Aumsville, Oregon
Wastewater Treatment Plant Improvements
ADDENDUM NO. 1

OWNER: **The City of Aumsville, Oregon**

FROM: Westech Engineering, Inc.

DATE: **June 24, 2026**

DRAWING
C205
61 OF 223
JOB NUMBER
2599.3220.0

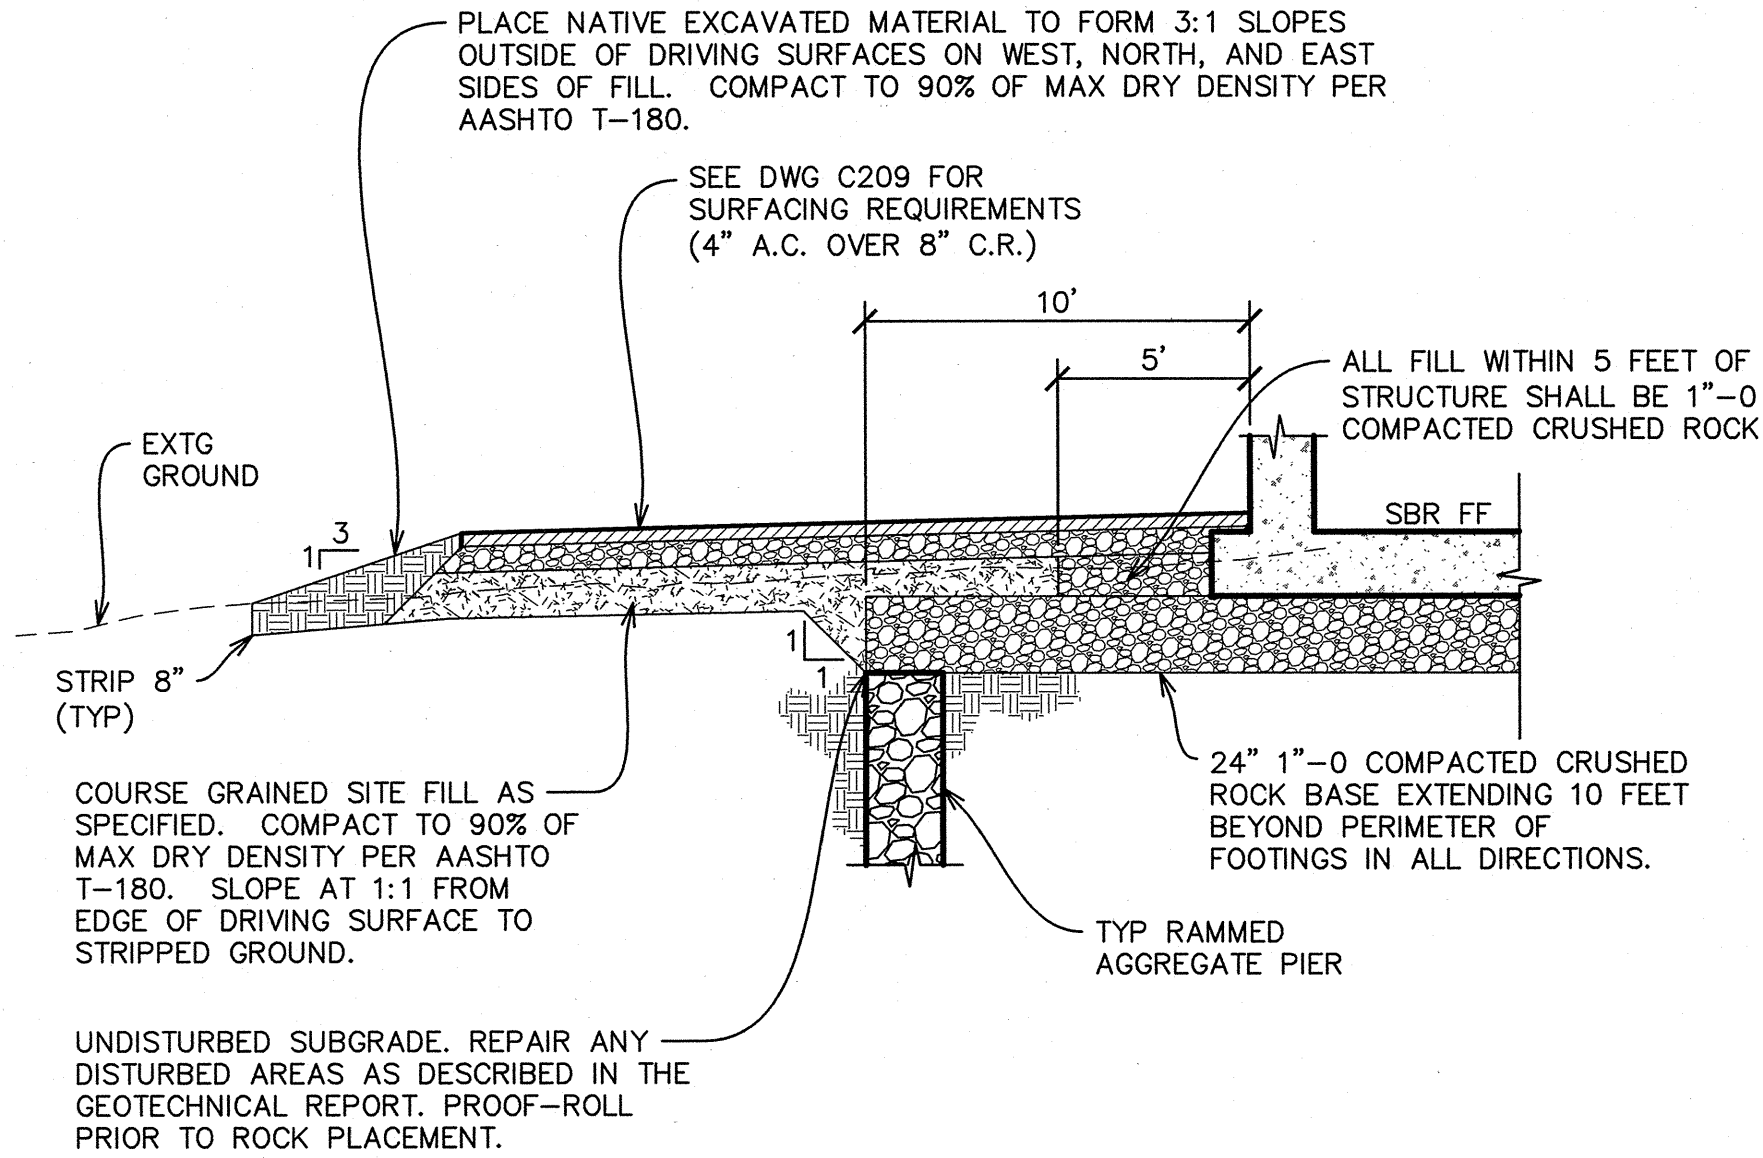
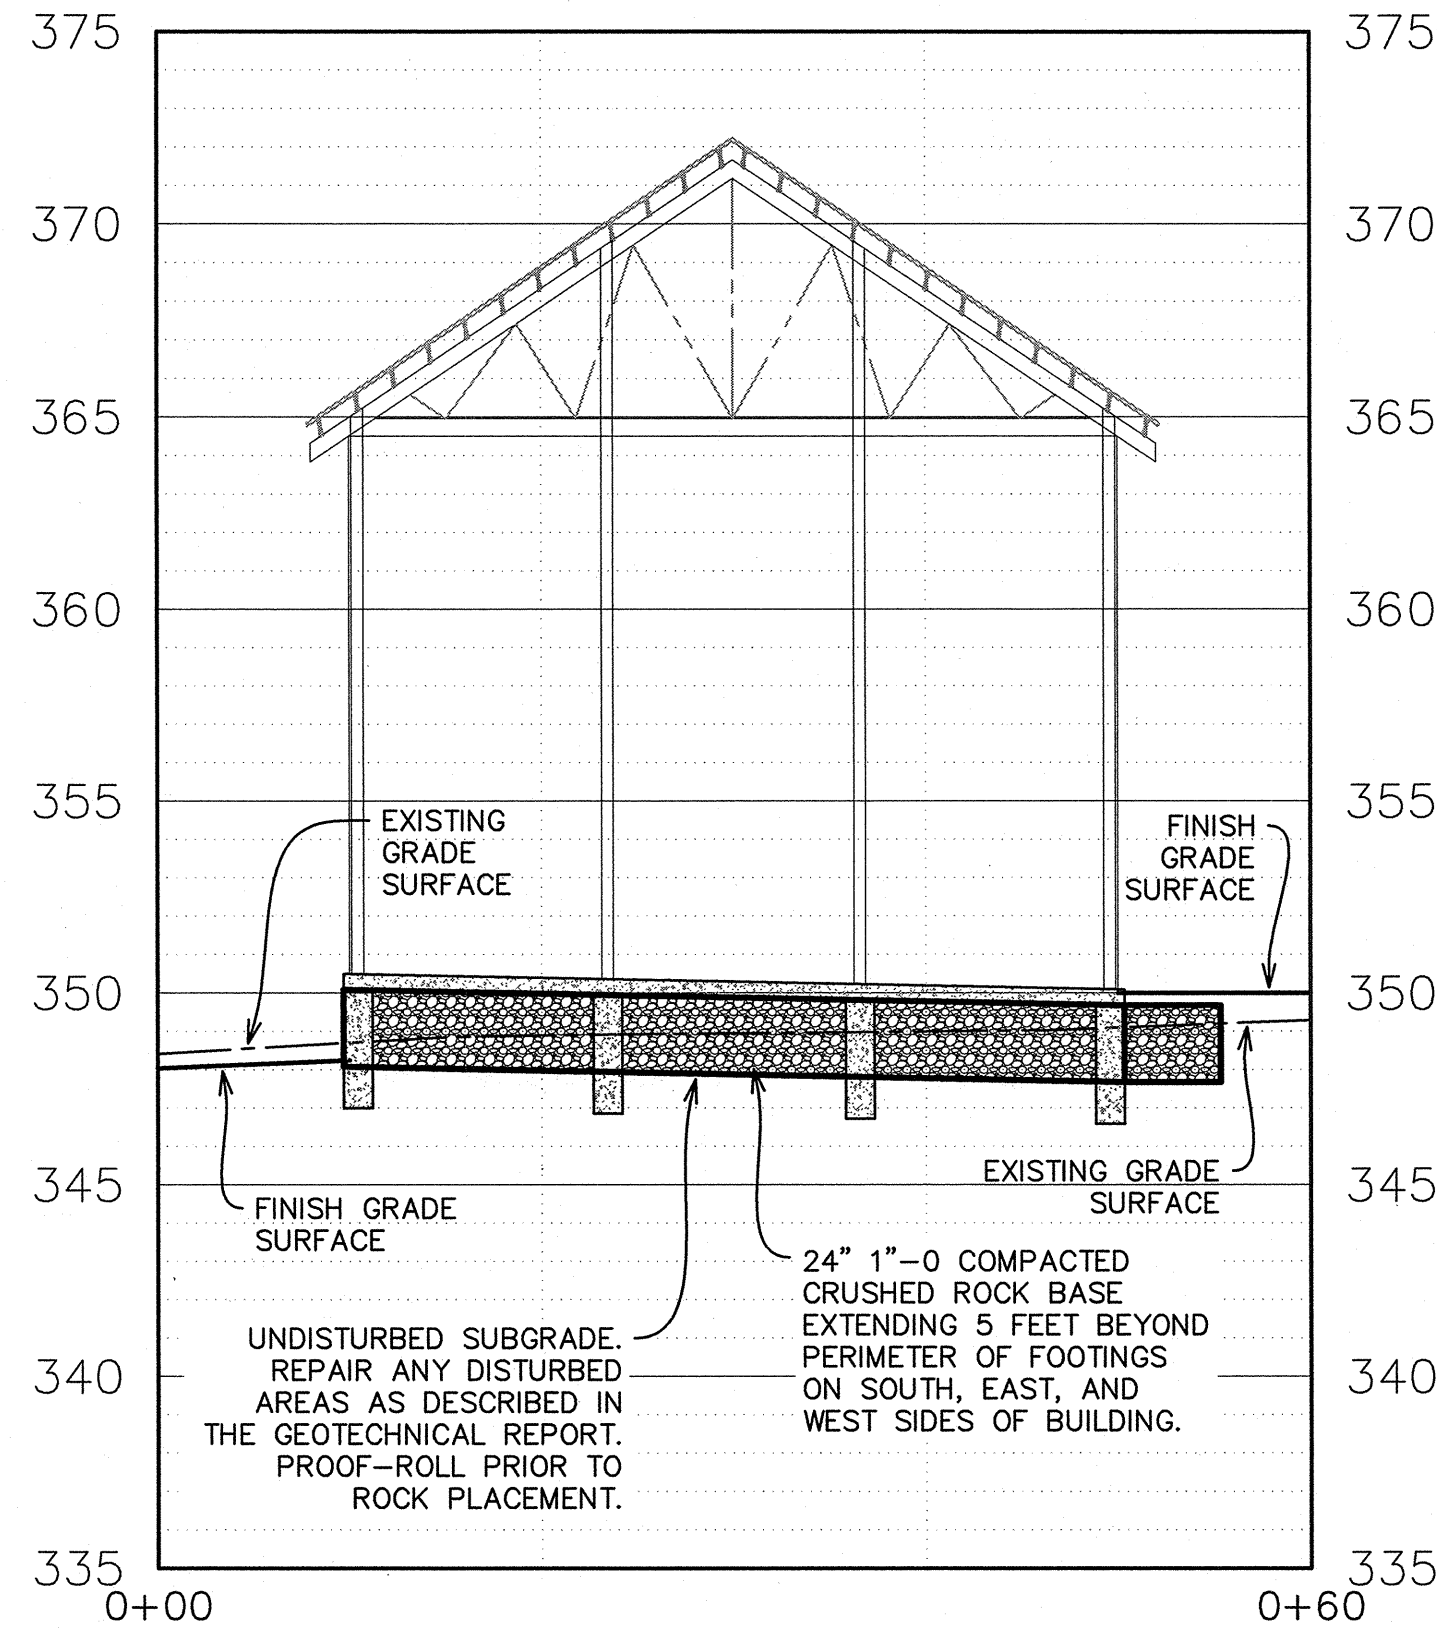
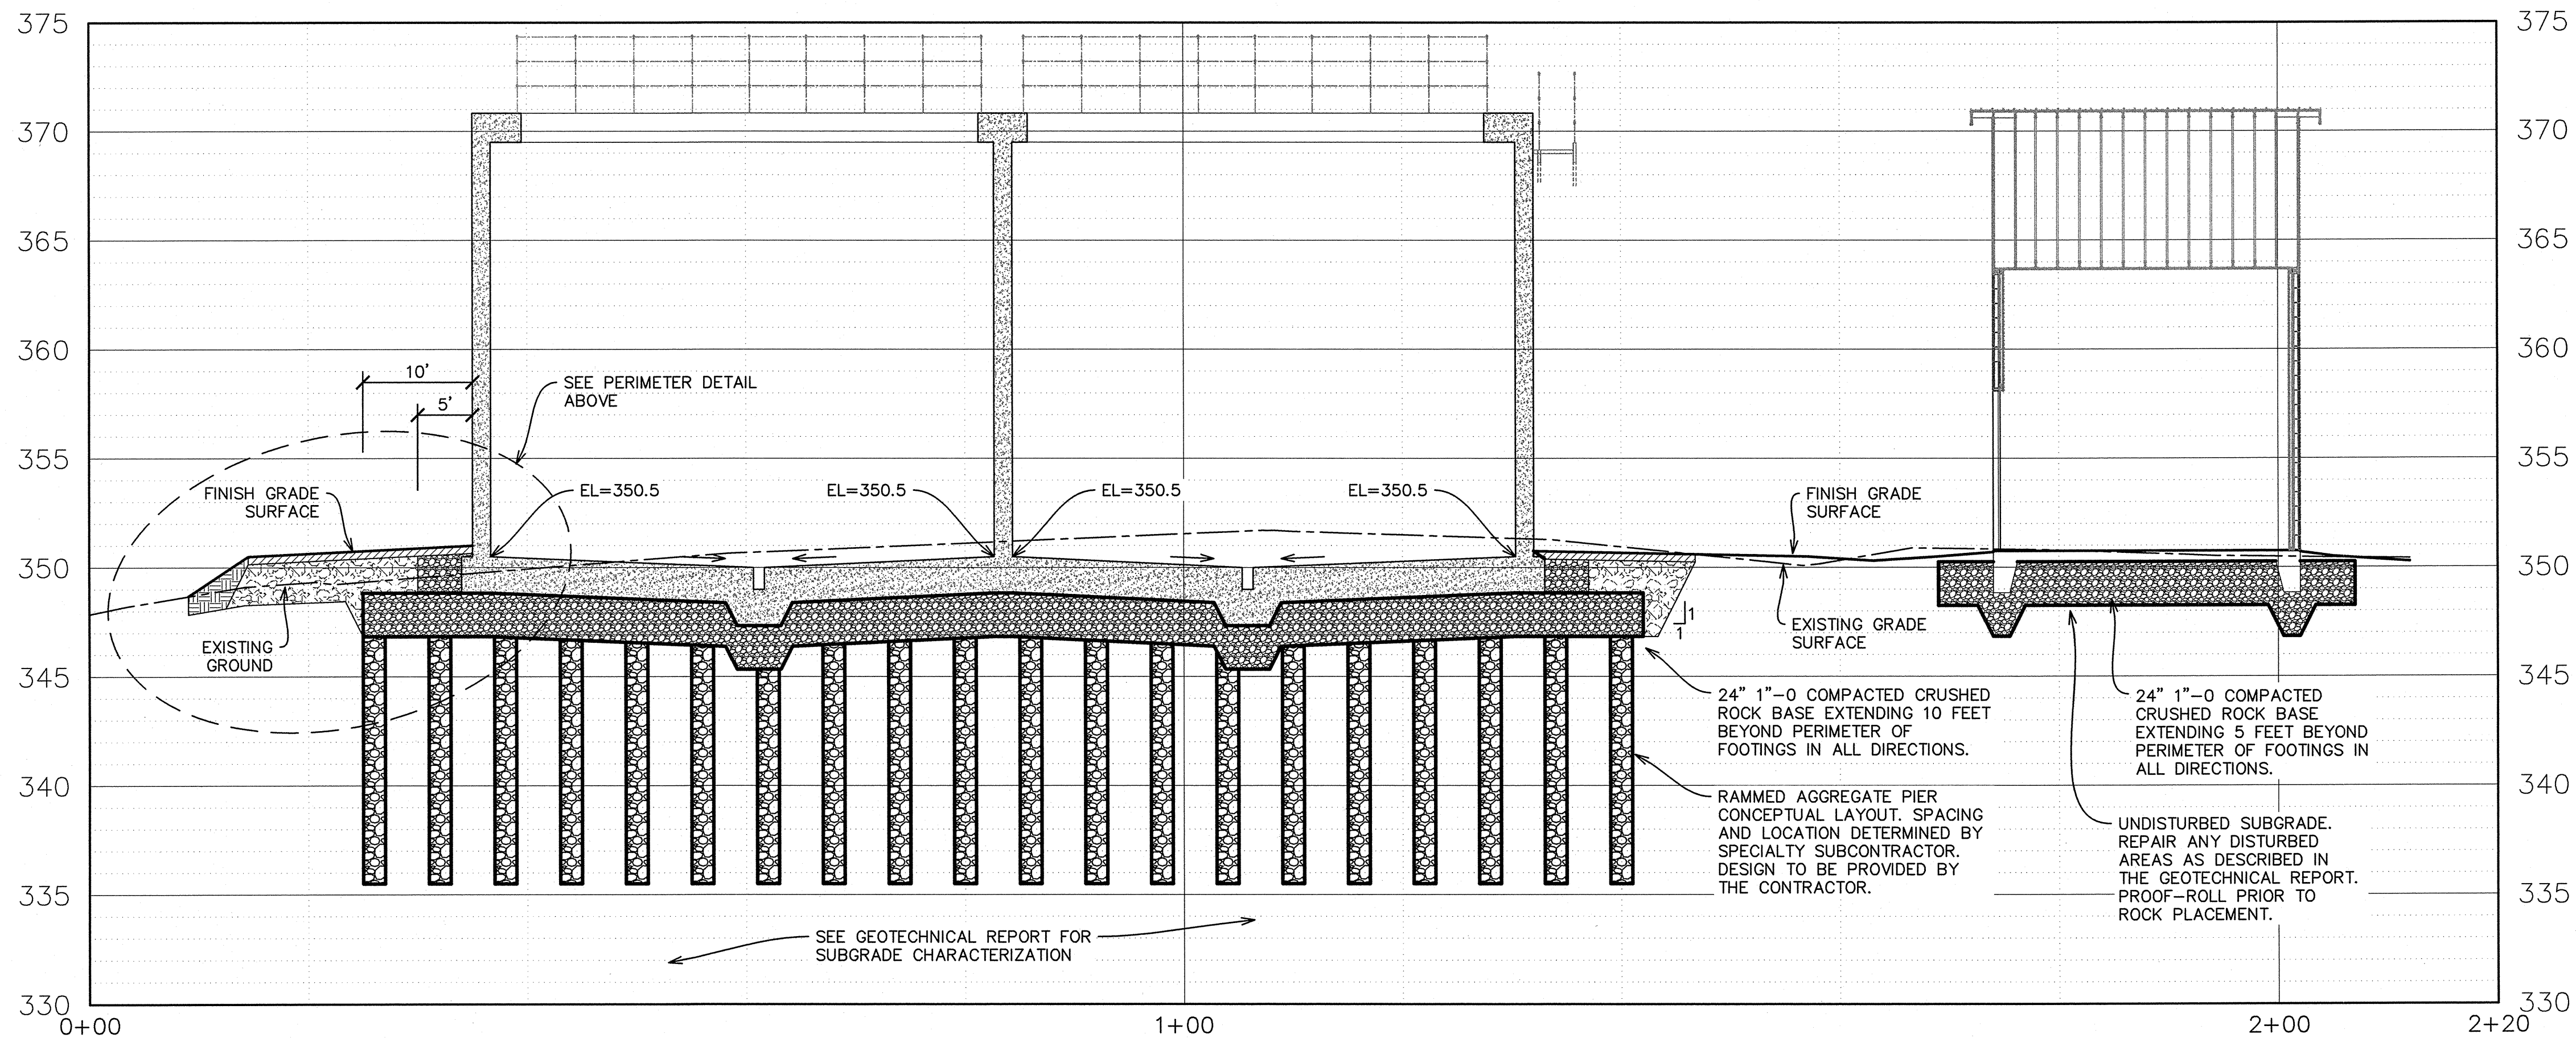
- 8. Drawing C205, (SBR Site Cross Section).
 - a. Delete this sheet entirely and replace with the revised drawing C205 attached hereto. The drawing has been revised to more accurately depict the concrete slab and baserock locations.

- 9. Drawing C206, (SBR Site Cross Section).
 - a. Delete this sheet entirely and replace with the revised drawing C206 attached hereto. The drawing has been revised to more accurately depict the concrete slab and baserock locations.
